METROPOLITAN GOVERNMENT OF NASHVILLE AND DAVIDSON COUNTY

STAFF RECOMMENDATION
328 Chesterfield Avenue
March 20, 2013

Application: Demolition—accessory structure; New construction—accessory structure;
Setback Reduction

Description of Project: Application is to demolish an existing accessory structure and construct a new accessory structure. The application involves a reduction to the side and rear setbacks.

Figure 2. Existing accessory structure to be demolished. Figure 3. C. 1951 Sanborn map shows accessory structure of similar size and location to the existing structure.

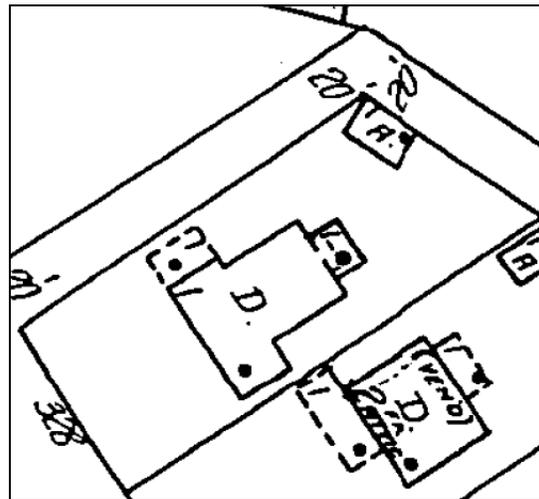
Demolition: The project involves demolishing an existing ten foot by twenty foot (10' X 20') accessory structure (see Figure 2). The date of construction of the accessory structure is unknown, but an accessory structure of a similar size and location does appear on the c. 1951 Sanborn map (see Figure 3). Staff finds that the accessory structure does not contribute to the historic character of the house at 328 Chesterfield or the Hillsboro West End Neighborhood Conservation Zoning Overlay. Staff therefore finds that the demolition of the structure meets Section III.B.2.b. of the *Hillsboro-West End Neighborhood Conservation Zoning Overlay: Handbook and Design Guidelines*.

EXISTING SITE PLAN

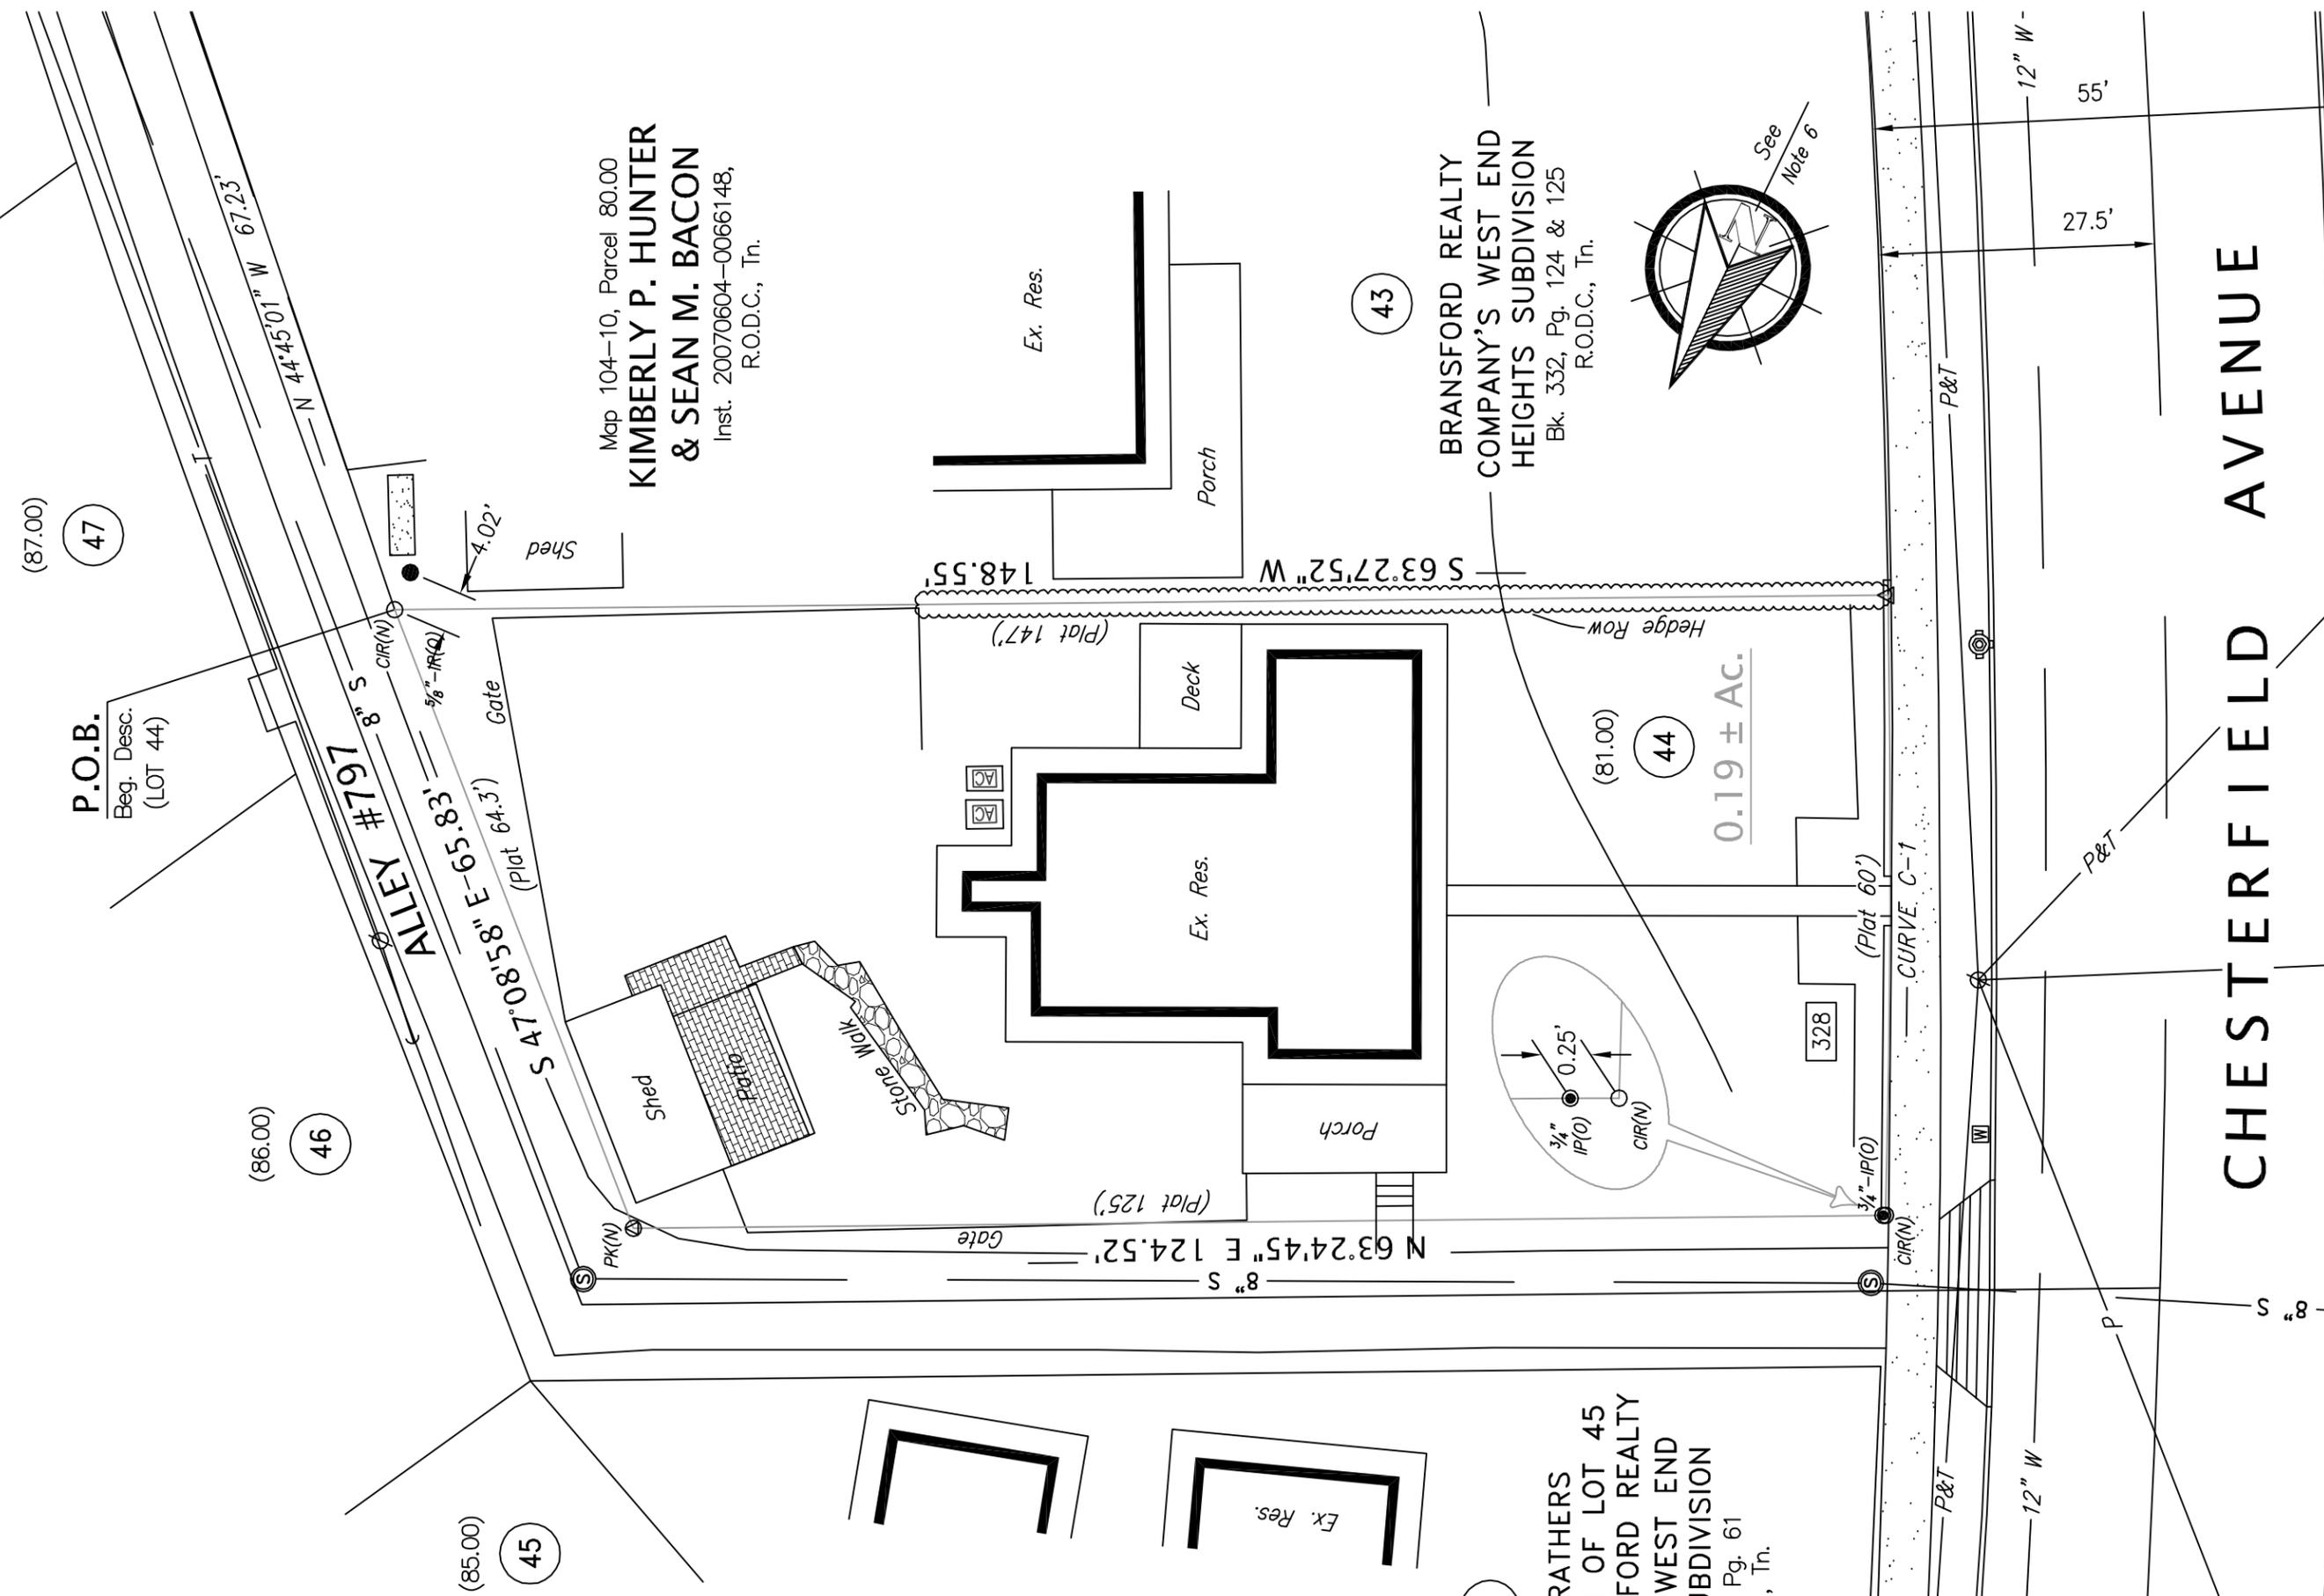
Location, Setback: A side alley runs along the left side of the property and connects to a rear alley that runs behind the property. The proposed accessory structure will be located in the back left portion of the property, just off the corner where the two alleys meet, which is historically appropriate (see Figure 4). The new structure will be in the approximate location of the existing structure. The existing structure sits just one foot (1') off the rear property line, and is a minimum of three feet (3') from the side property line (see Figure 5). The proposed structure will also be one foot (1') from the rear property line and will be a minimum of one foot (1') from the side property line. Base zoning requires that the structure be at least three feet (3') from the rear and the side property lines. The project therefore requires a setback reduction. Staff finds the setback reduction to be appropriate in this instance because the Sanborn map shows that historically, there was an accessory structure that sat on or near the rear and side property lines. In addition, there is an existing accessory structure in approximately the same

location as the proposed new structure. Finally, the structure will have a chamfered left side that ensures that the structure is only one foot (1') from the side property line at one point; the structure will be between one foot (1') and four feet (4') from the side property line. Staff finds that the new accessory structure's location and setback meet Section II.B.1.c. and II.B.1.i. of the *Hillsboro-West End Neighborhood Conservation Zoning Overlay: Handbook and Design Guidelines*.

FRONT ELEVATION

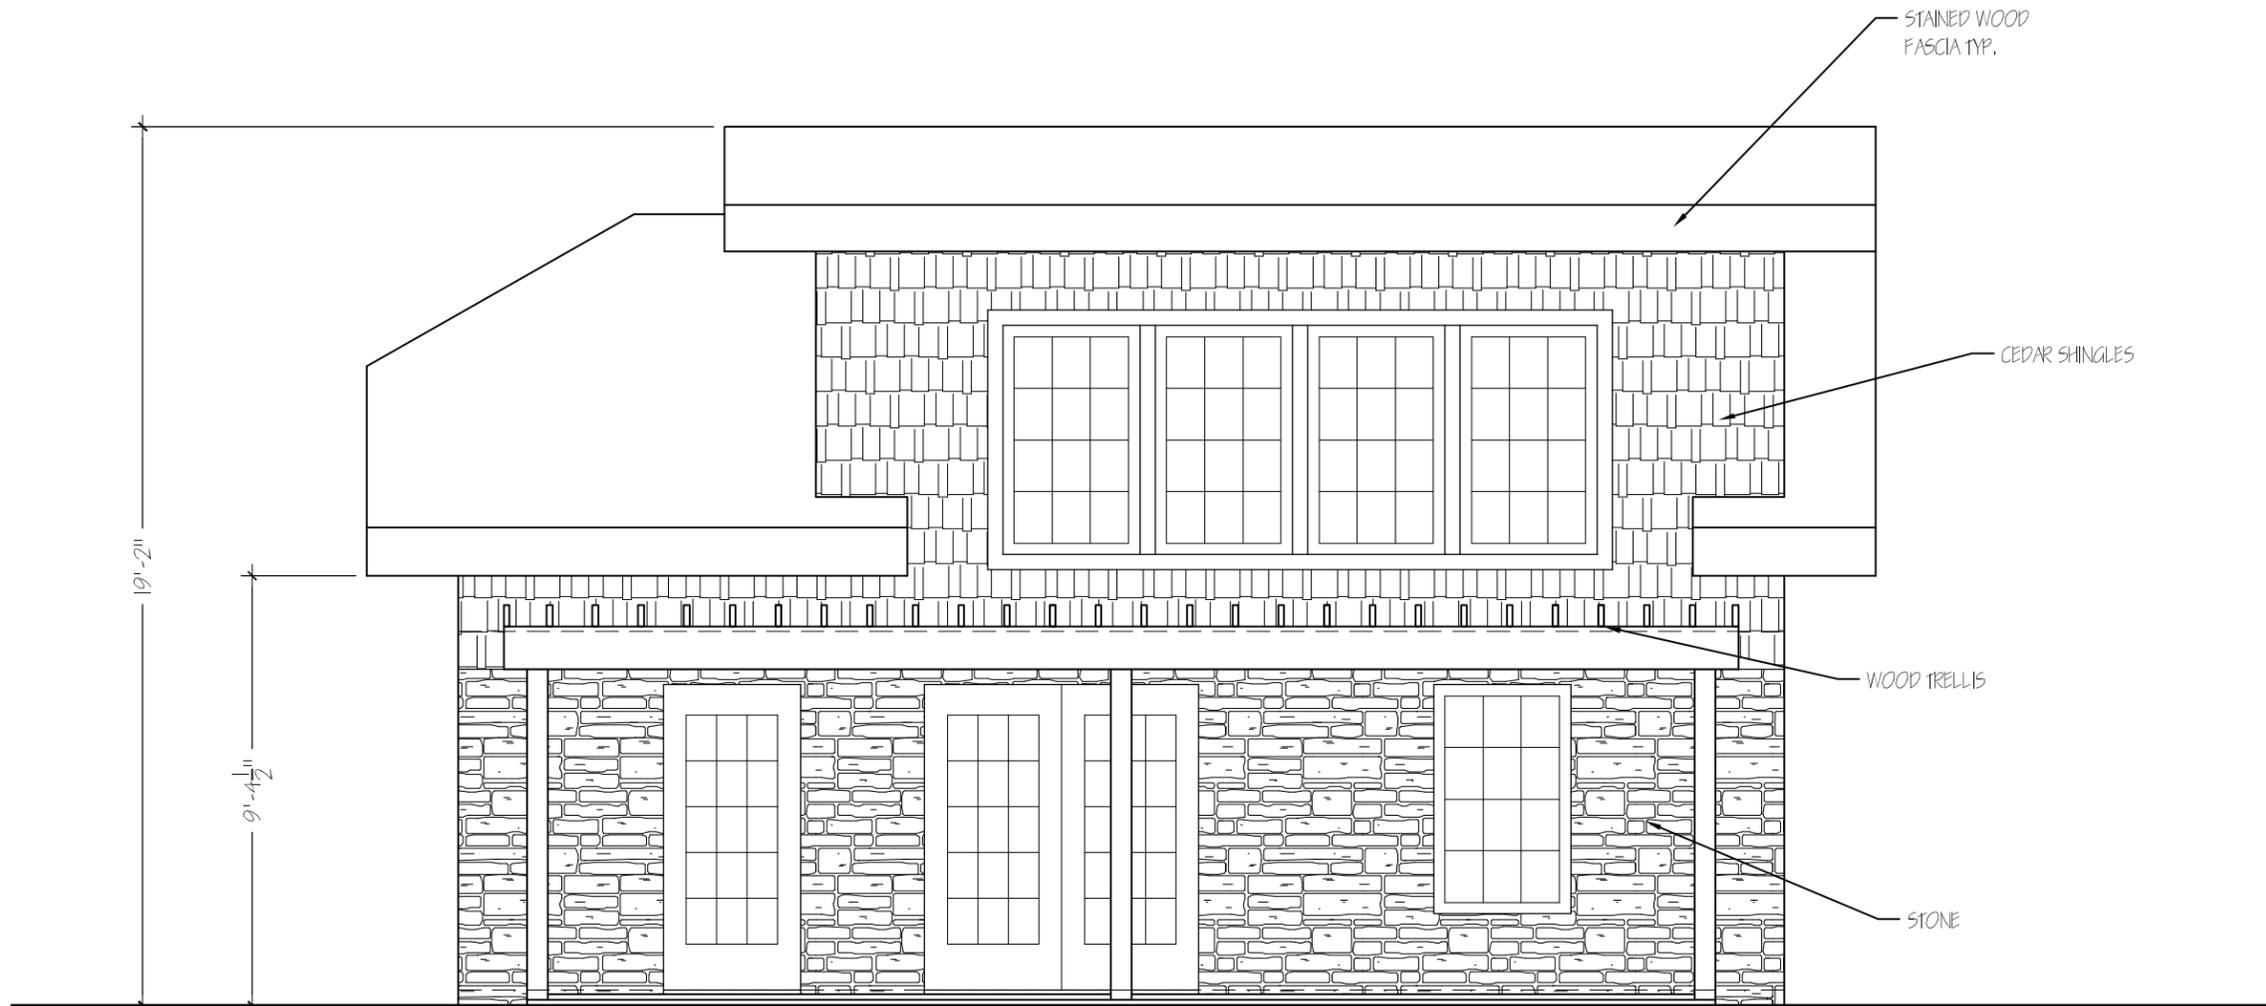
Roof Form: The structure will have a shed roof form with a slope of 4/12. A wall dormer is proposed for both the house-facing façade and the alley-facing façade. The dormer will have a shed roof with a slope of 1/12. While the Commission has found wall dormers to be inappropriate on primary structures, staff finds that this wall dormer and the low-slope shed roof is appropriate because the accessory structure is more utilitarian in nature and will be located at the back of the lot. Staff finds that the roof form is appropriate for an accessory structure, and meets Sections II.B.1.e. and II.B.1.i. of the *Hillsboro-West End Neighborhood Conservation Zoning Overlay: Handbook and Design Guidelines*.

Proportion and Rhythm of Openings: The structure will not be used as a garage and therefore does not have a garage door. One pedestrian door and a set of French doors will be on the house-facing façade. The house-facing façade also has one window on the ground floor and a set of four windows in the wall dormer. The remaining window openings on the other façades are small, clerestory-type windows. Staff finds that the accessory structure's proportion and rhythm of openings are appropriate for an accessory structure and meet Section II.B.1.g. and II.B.1.i. of the *Hillsboro-West End Neighborhood Conservation Zoning Overlay: Handbook and Design Guidelines*.
